City of Santa Fe, New Mexico

memo

2026-012285-HDRB. 619 West Alameda St., Westside-Guadalupe Historic District, Contributing, Dura Build Construction, agent for Max Scott, owner, proposes to construct a 169 sq. ft. addition to a height of 11'-6" and a freestanding 763 sq. ft. casita to a height of 11'-1", where the maximum allowable height is 14'-10".

Figure 5: Previous Floor Plan Compared to Proposed Plan

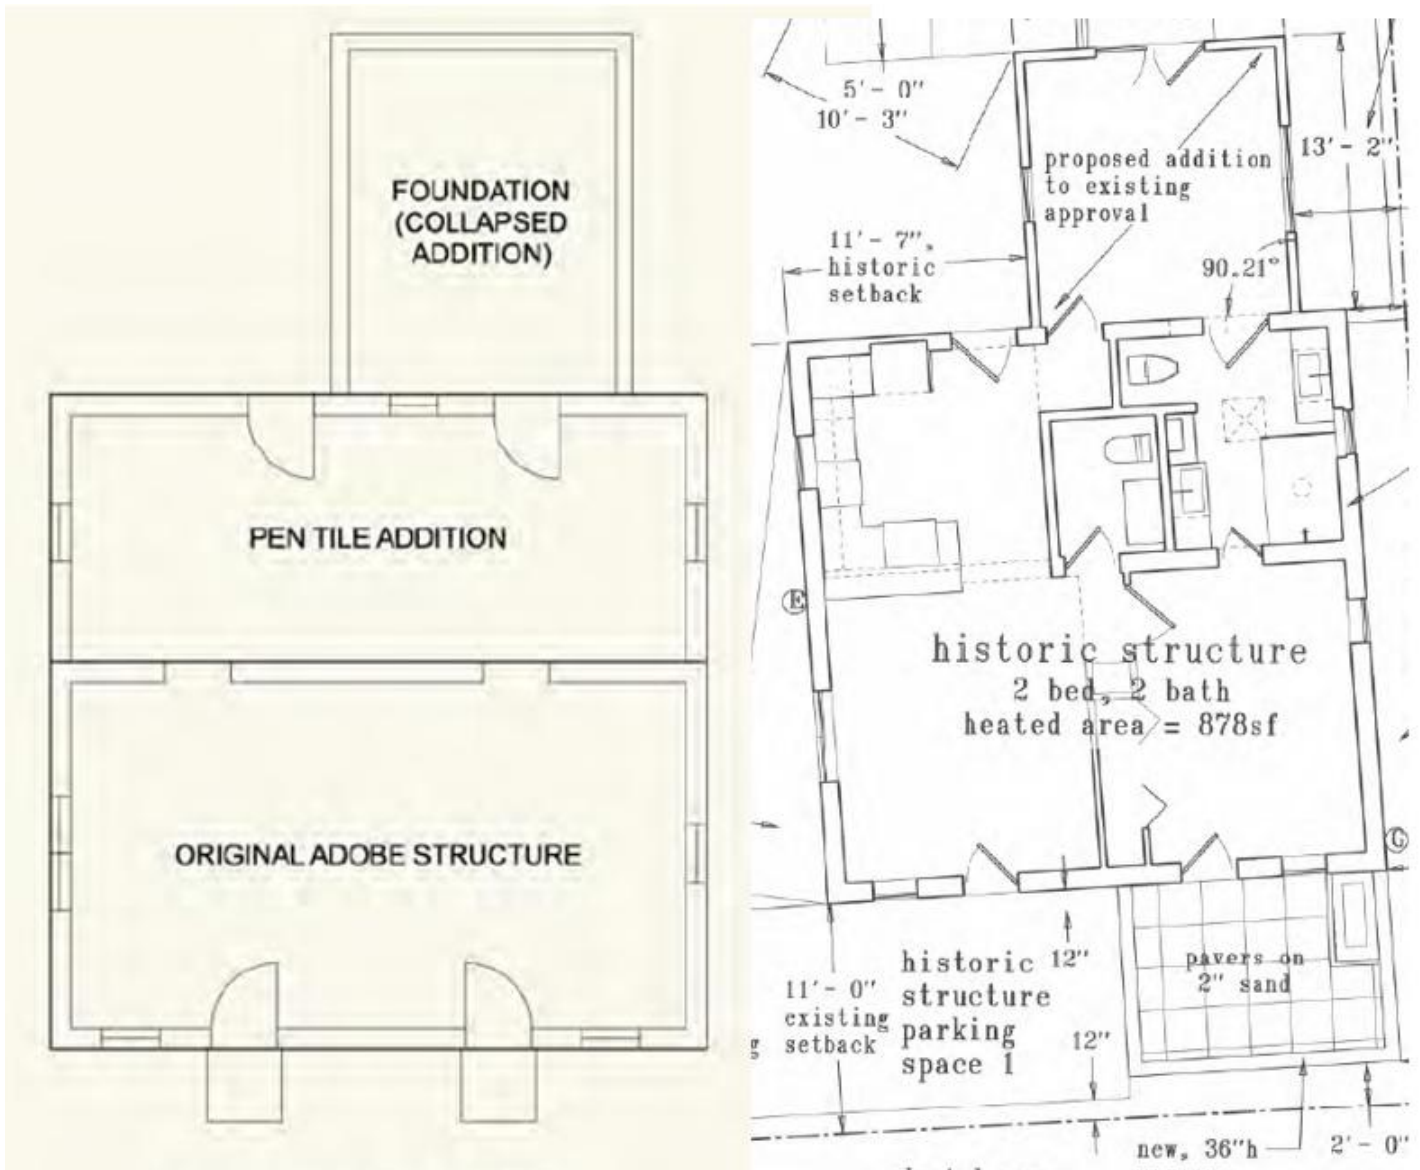
- 1) Construct a 169 sq. ft. addition to a height of 11’- 6” to replace the demolished 1975 addition and create a foyer on the north elevation of the residence.

Figure 5: Proposed Site Plan

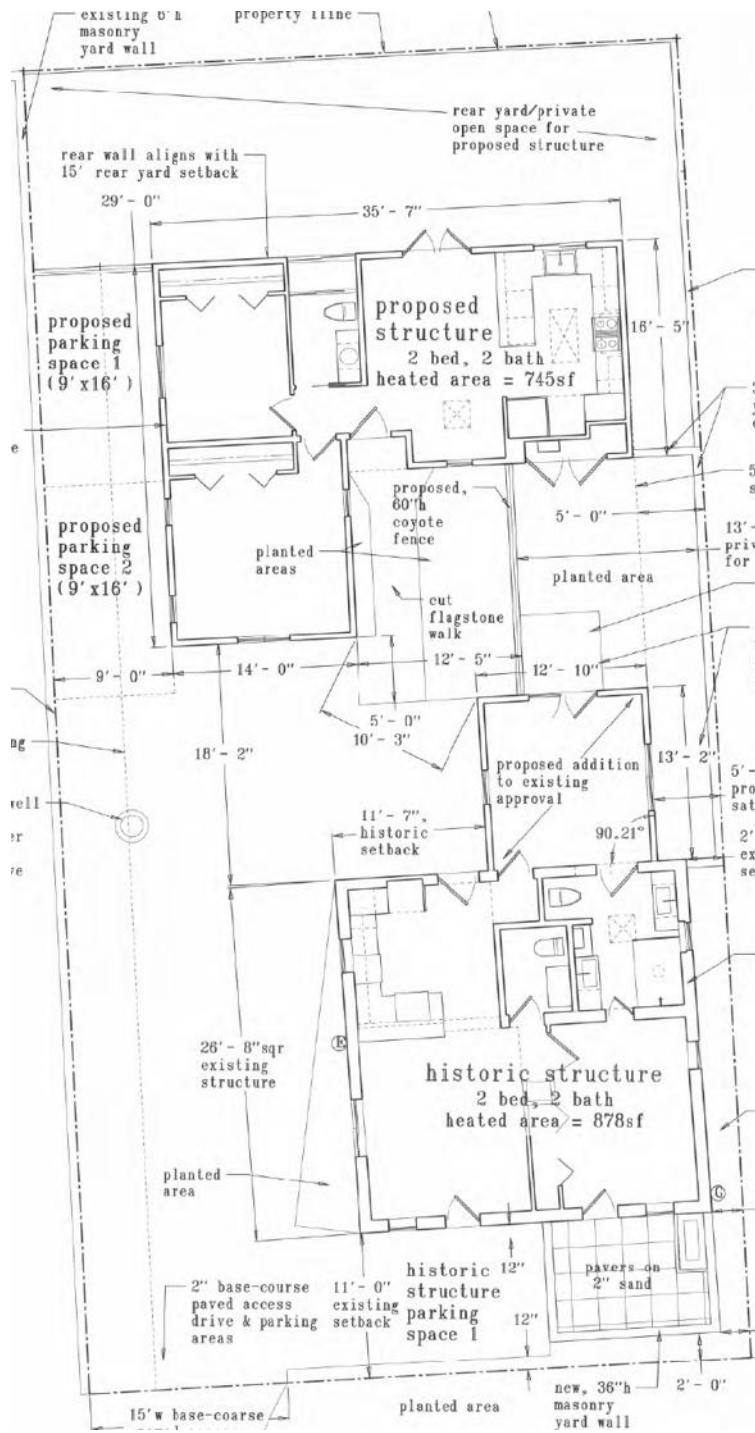
- 2) Construct a 745 sq. ft. residential structure to a height of 10'-6½" where the maximum allowable height is 14'-10" in a recent Santa Fe style
 - a. The roof will be flat with a parapet
 - b. Windows include single-lite, double-hung wood-clad windows on each elevation and a single sliding window on the north elevation.
 - c. Doors include a 4-panel solid wood door and a double 4-panel solid wood door on the south and a single-lite French door on the north.
 - d. Stucco will be cementitious in suede color.

- 3) Construct a 60" high interior coyote fence between the structures.

4) Hardscaping is proposed.
